## **TECHNICAL BULLETIN 06**

**DATE:** 30 June 2022

**SUBJECT:** Fathom-X PCBA populated with incorrect TVS diode

Figure 1. Location of affected TVS diode

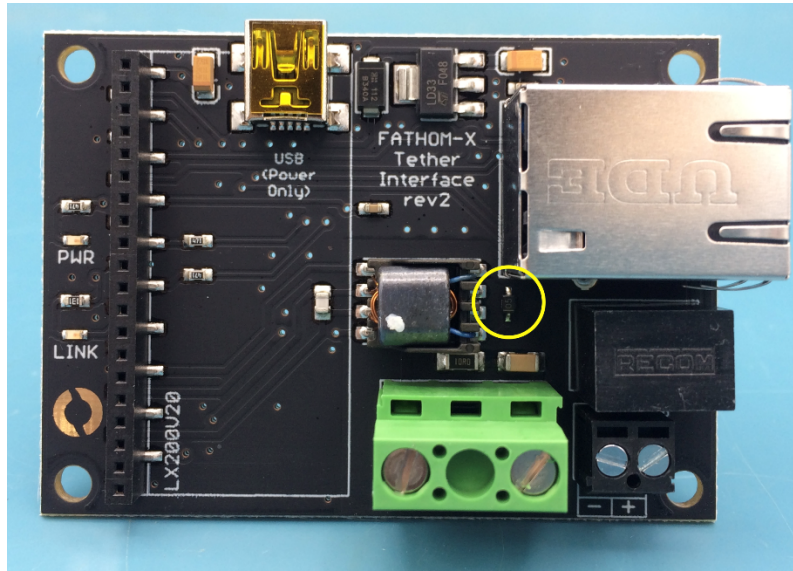
**IDENTIFICATION:** Blue Robotics recommends visually inspecting all Fathom-X Tether Interface Boards from orders shipped between May-June 2022 for incorrect diode component. Figure 1 shows the affected component TVS diode located between the connector corner and transformer. The correct diode is labeled “5C” and the incorrect diode is labeled “05” as shown in Figure 2.

**CUSTOMER ACTION:** If you have any affected Fathom-X Tether boards or related products, please contact our support team at [support@bluerobotics.com](mailto:support@bluerobotics.com) with all available order information to receive replacement boards.
